Municipal Planning & Design Review Commission
Regular Meeting Agenda
Thursday, May 20, 2021, 5:30 PM
City Hall, Lakeland, Tennessee 38002

Subject: Action on a recommendation to the Board of Commissioners for an Outline Plan – Chapel Lakes Planned Development.

**RE: Chapel Lakes Planned Development
Outline Plan Submittal**

A5 EXTERIOR ELEVATION - NORTH CANOPY
1/8" = 1'-0"

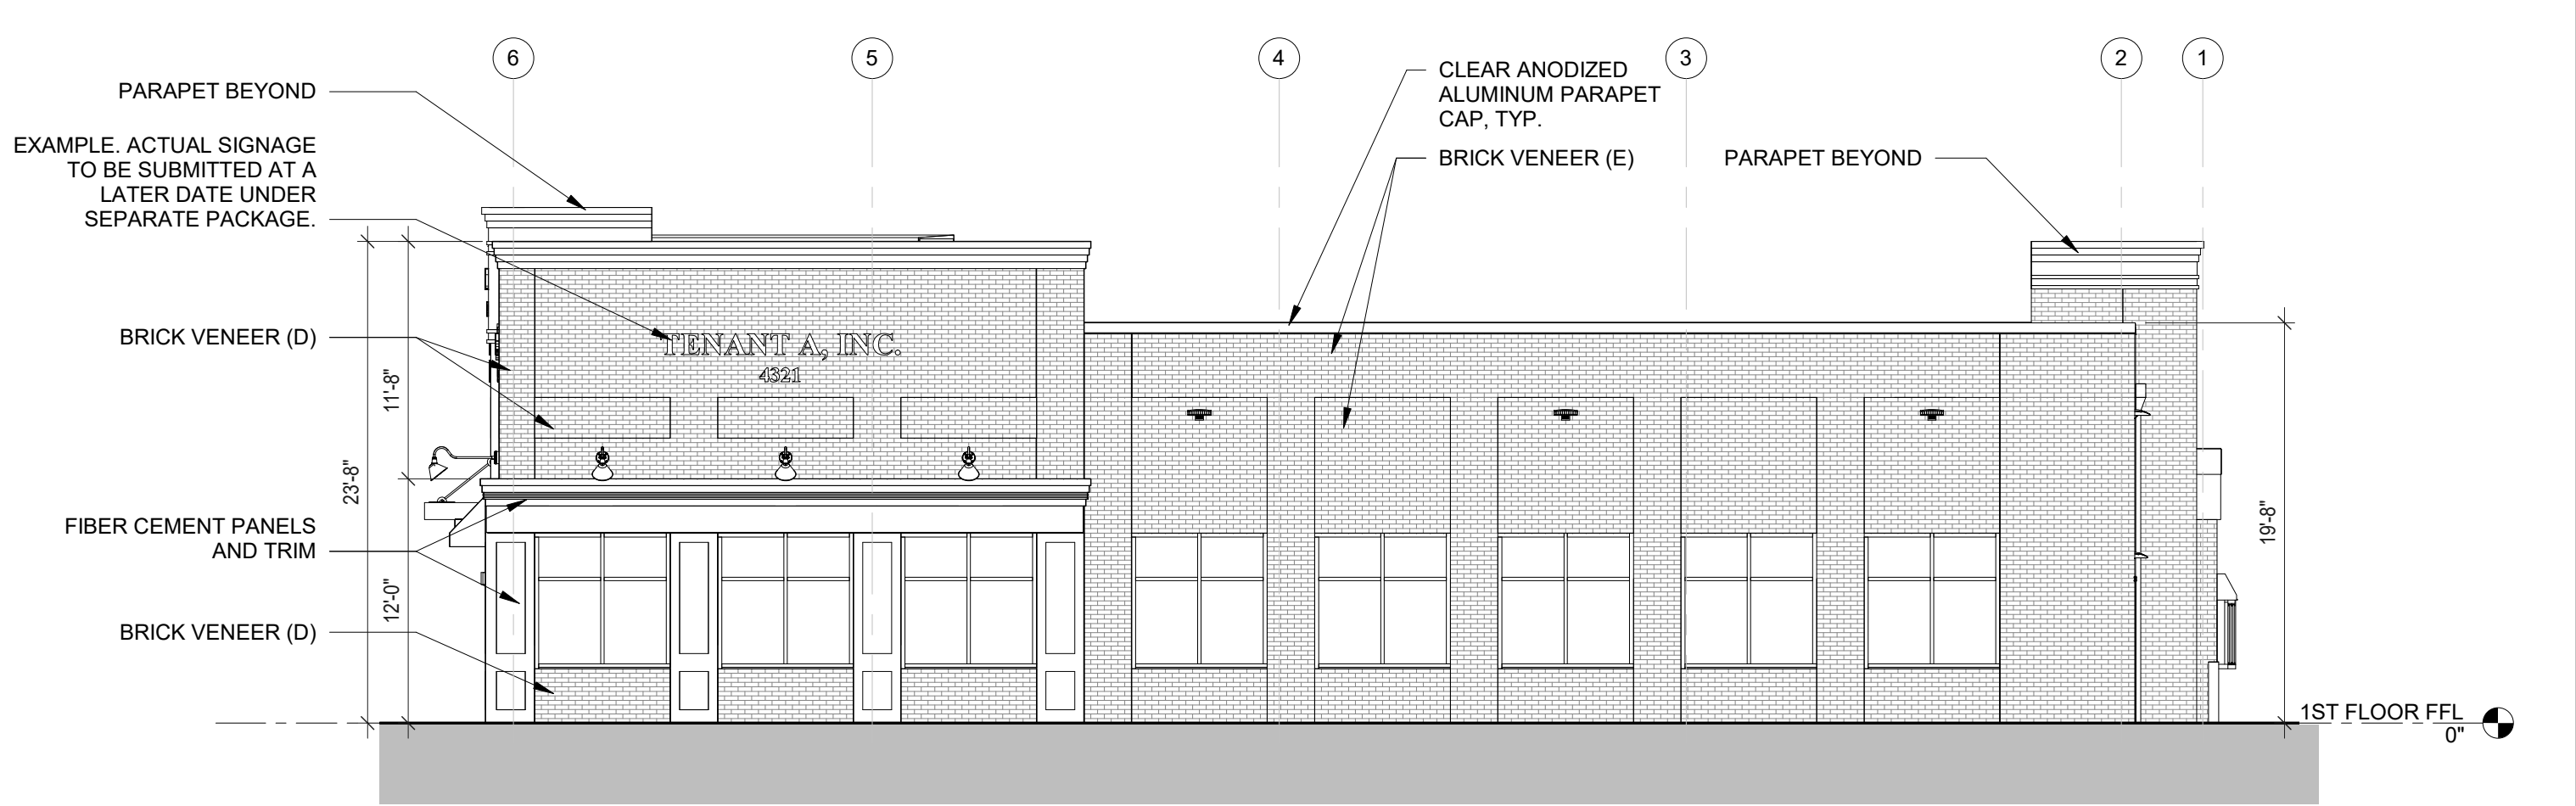
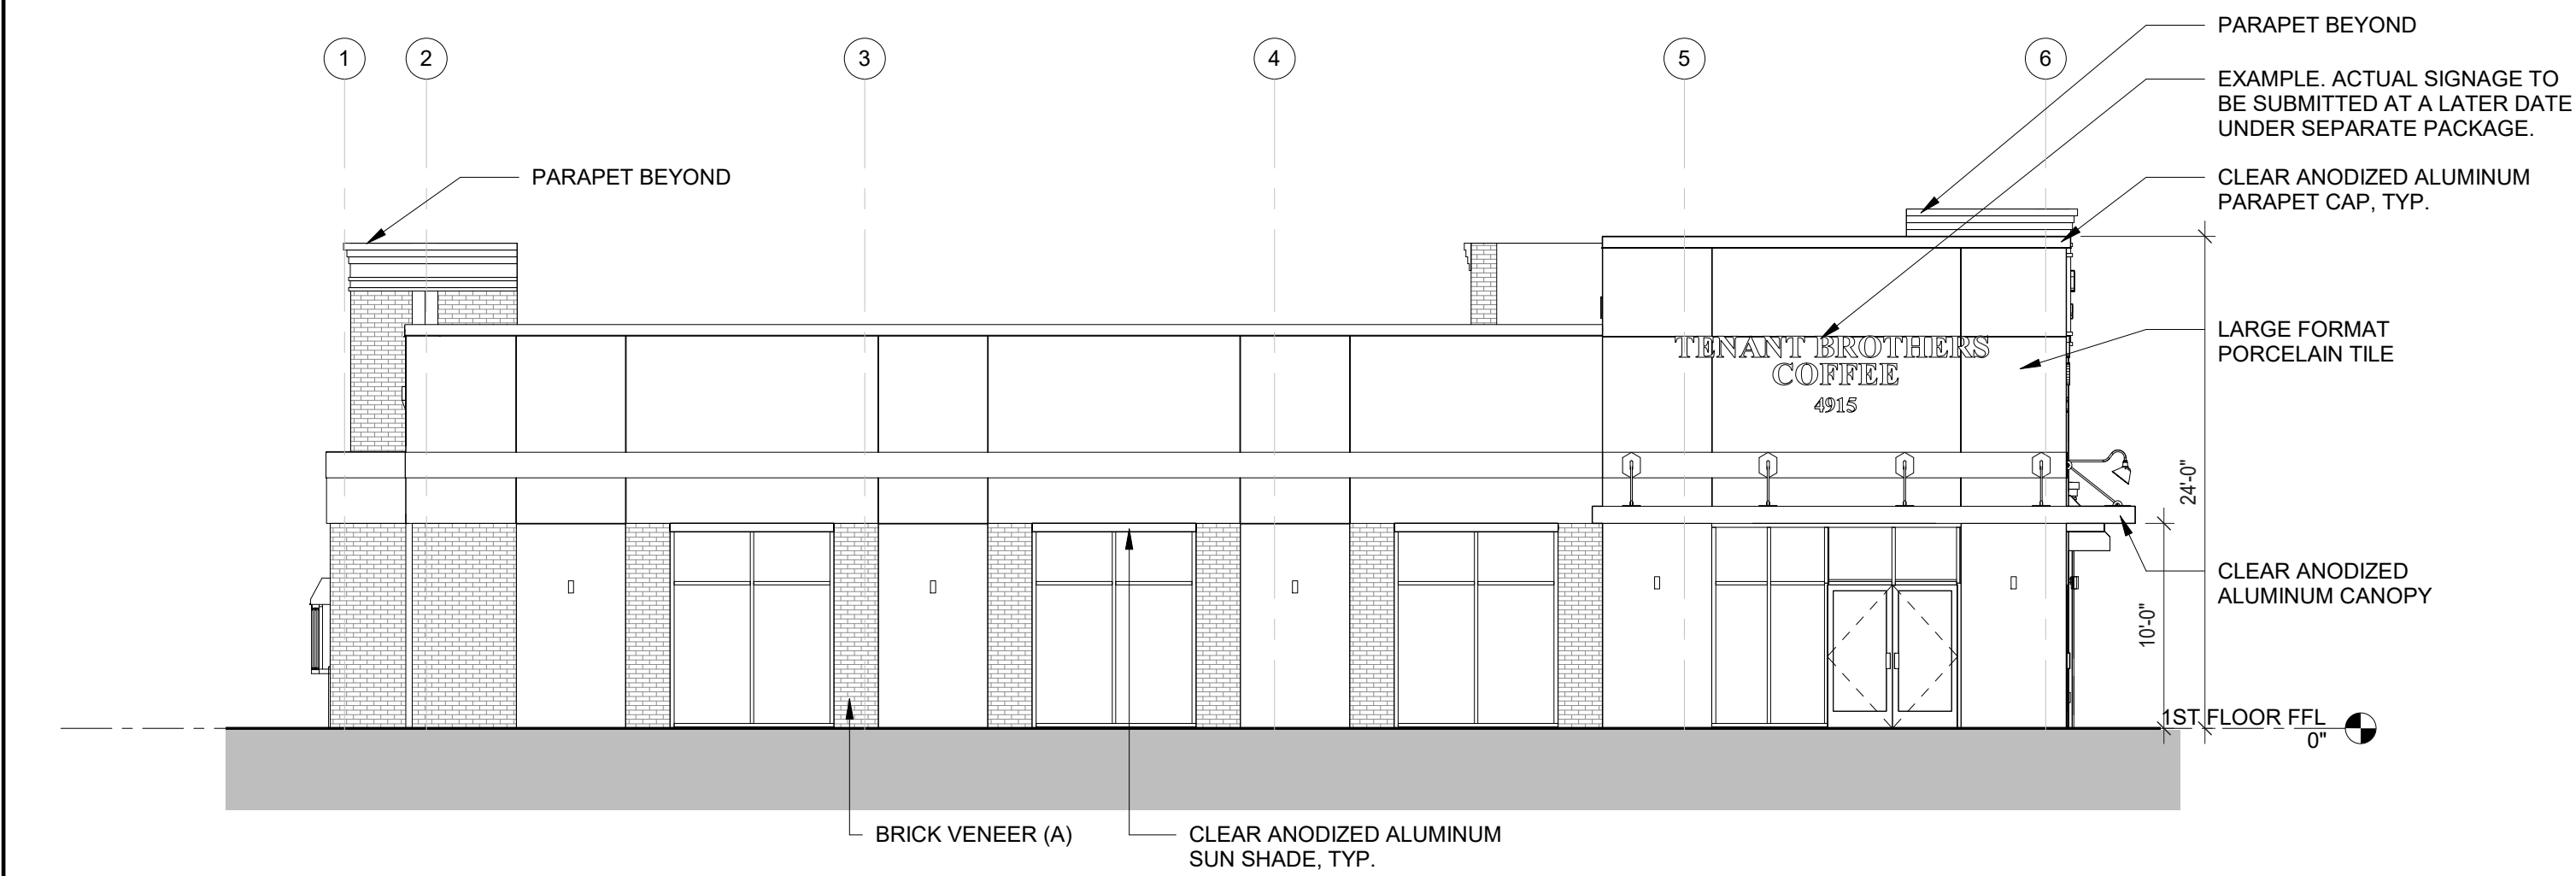
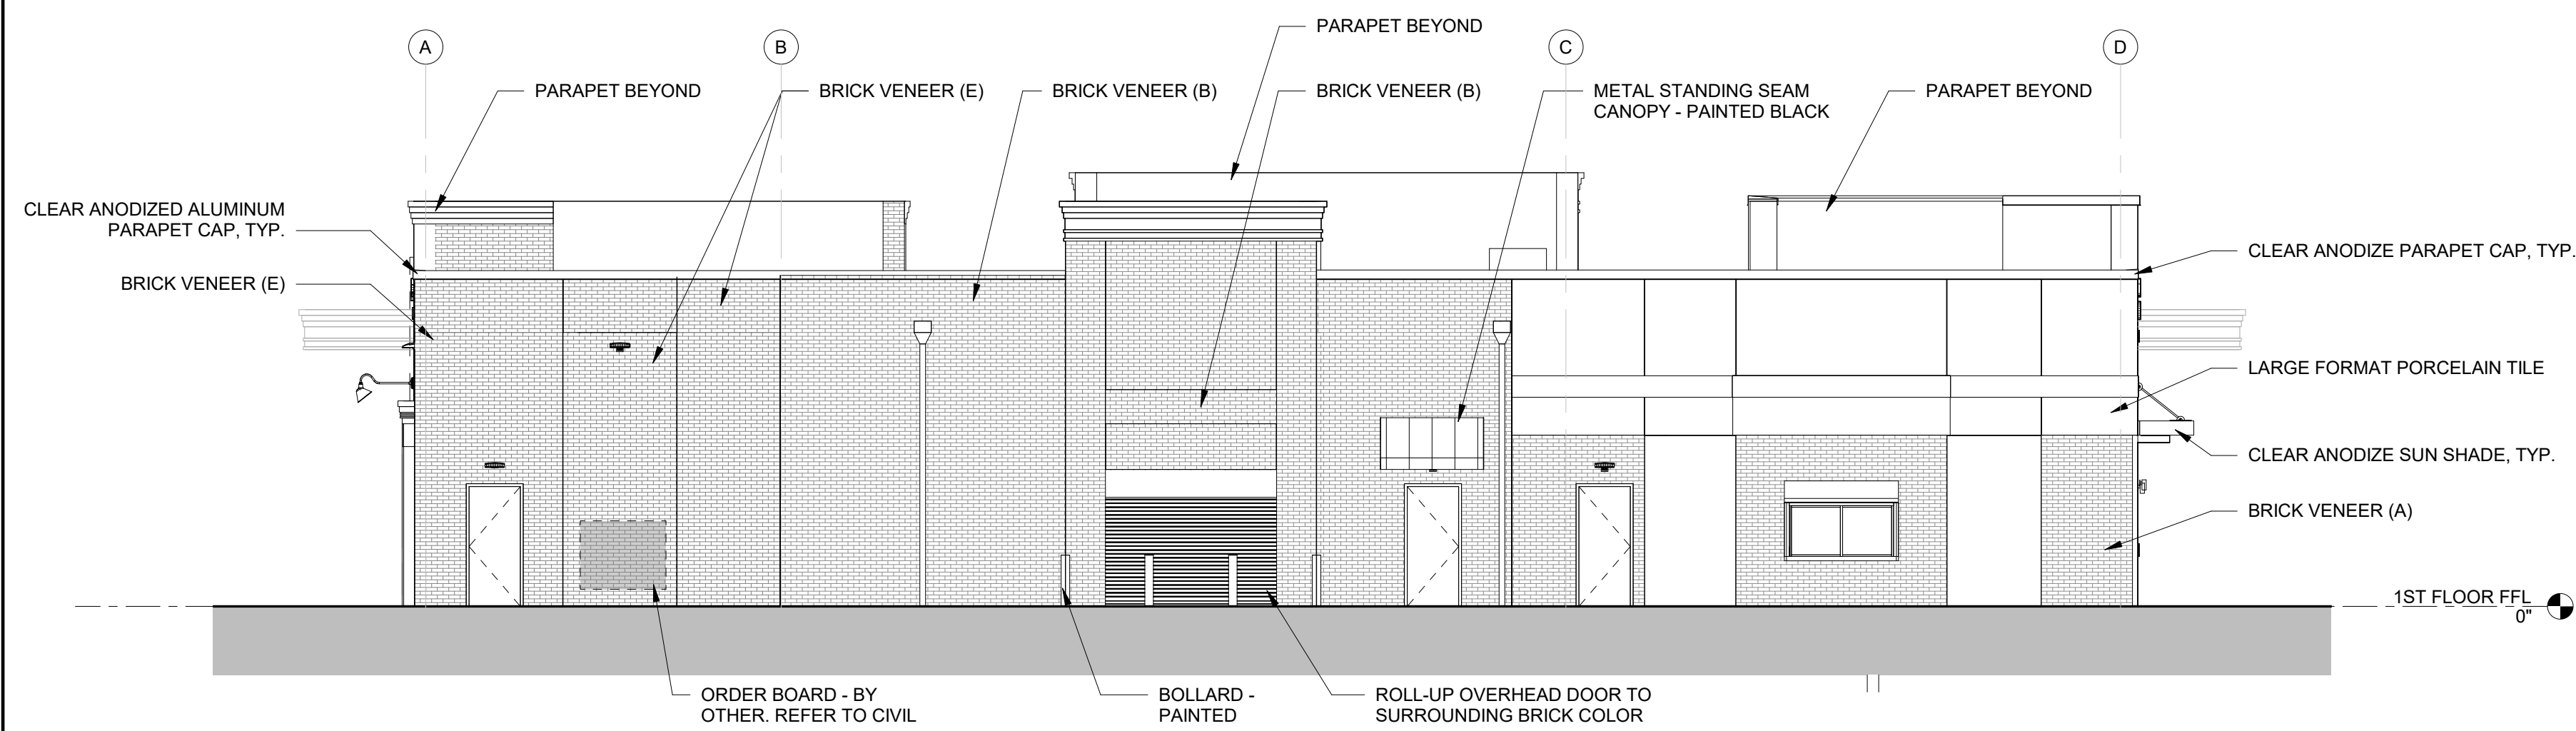
RESPONSE: Please see the attached sheet A1.4.
6. Page Label: 16 – Provide an east or west elevation of the canopy. The PD requires the pumps are screened in the east west direction.
